LR-N12-0067 LAR H12-01

> Hope Creek Generating Station Renewed Facility Operating License No. NPF-57 NRC Docket No. 50-354

Subject: License Amendment Request to Correct Technical Specification and Facility Operating License Editorial Items

(10) Initial Startup Test Program (Section 14, SSER No. 5)

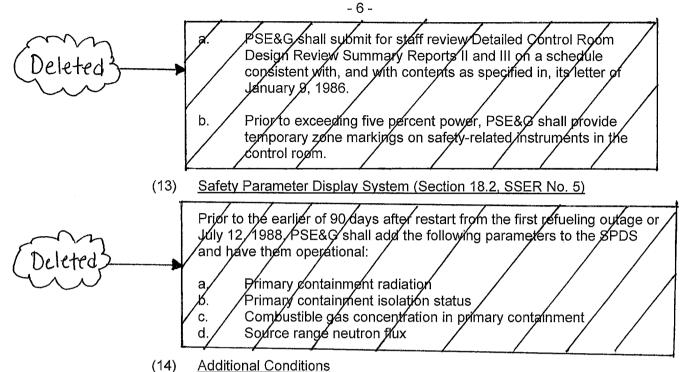
FOL 2.C.(9) is a historical requirement that was completed and should be deleted.			
14.	FOL 2.C.(10) required that changes to the Initial Startup Test Program be reported to the NRC. This requirement was completed through a series of correspondence, including PSE&G letter number NLR-N87045 (ADAMS Accession No. 8703190427), dated 3/16/1987.	FOL page 5	FOL 2.C.(10)	Delete FOL 2.C.(10)
	FOL 2.C.(10) is a historical requirement related to the Initial Startup Test Program that is no longer applicable and should be deleted.

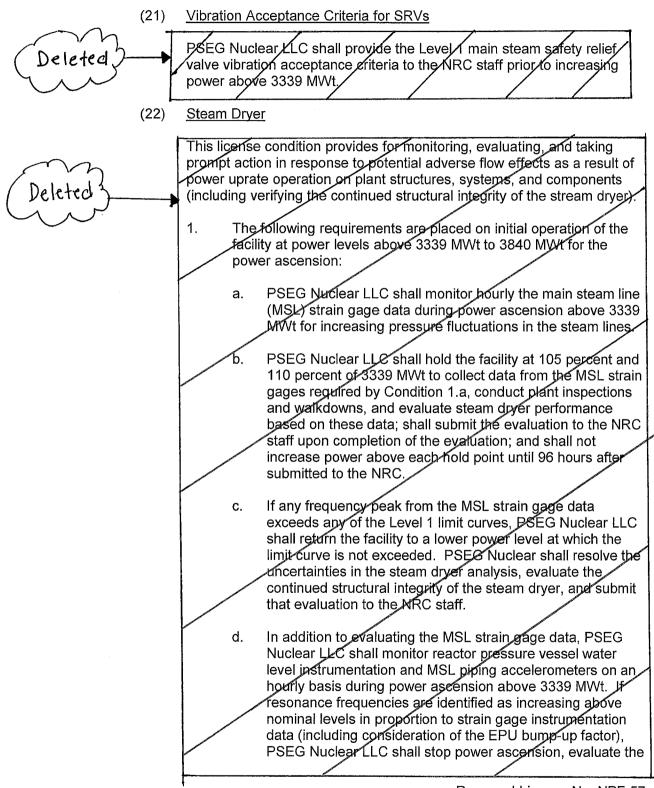
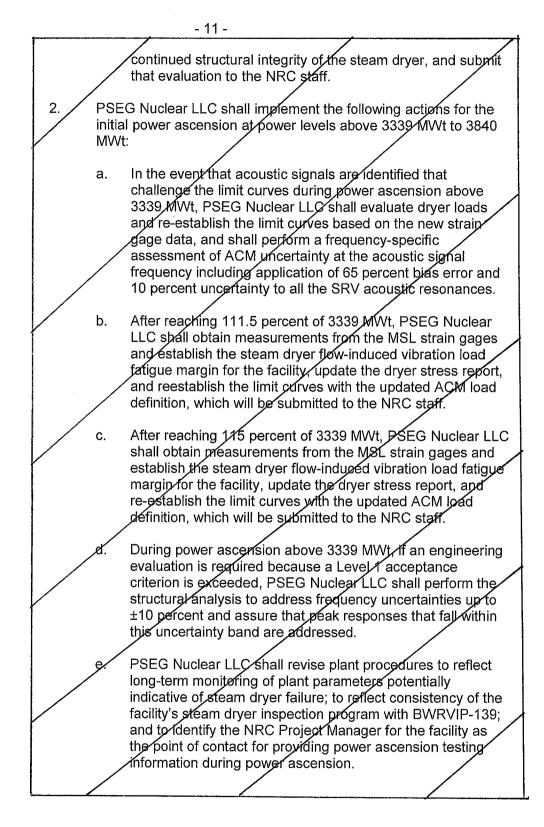
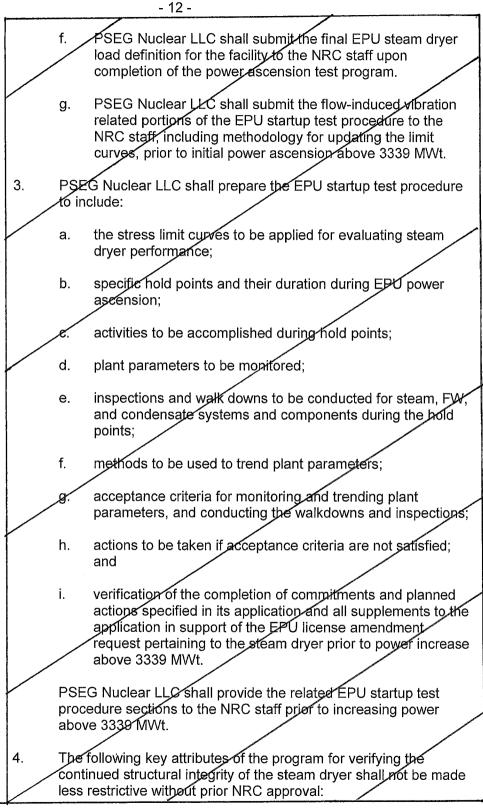
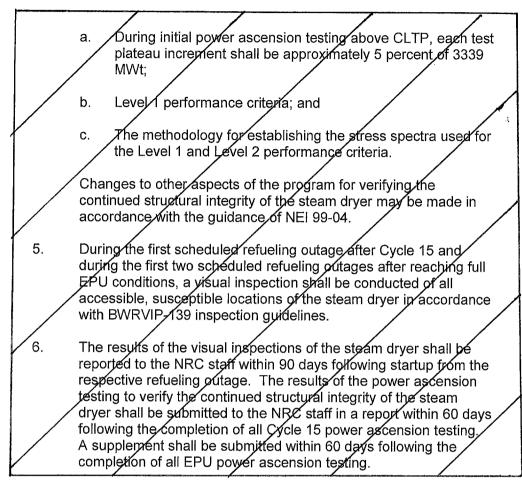
ltem	Description	Section / Page	TS / FOL	Action
	Acceptance Criteria for SRVs specifically related to Extended Power Uprate (EPU), which was completed in 2008 via Amendment 174.			
	The requirement to provide the Level 1 main steam safety relief valve vibration acceptance criteria to the NRC prior to increasing power above 3339 MWt was completed via PSEG letter number LR-N08-0123, dated 5/19/2008 (ADAMS Accession No. ML081480508).			
	FOL 2.C.(21) is a historical requirement related to EPU implementation that is no longer applicable and should be deleted.

18.	(Reference 4) FOL 2.C.(22) contains requirements related to EPU regarding the Steam Dryer. These requirements were completed with the implementation of EPU, as documented in PSEG letter numbers LR-N08-0199, dated 9/2/2008 (ADAMS Accession No. ML082540328), LR-N08-0224, dated 10/27/2008 (ADAMS Accession No. ML083100826), LR- N08-0123, dated 5/19/2008 (ADAMS Accession No. ML081480508), LR-N08-0111, dated 5/8/2008 (ADAMS Accession No. ML081360491), and LR-N09- 0167, dated 7/30/2009 (ADAMS Accession No. ML092230344). FOL 2.C.(22) is a historical requirement related to EPU implementation that is no longer applicable and should be deleted.	FOL pages 10 - 13	FOL 2.C.(22)	Delete FOL 2.C.(22)
	(Reference 4)
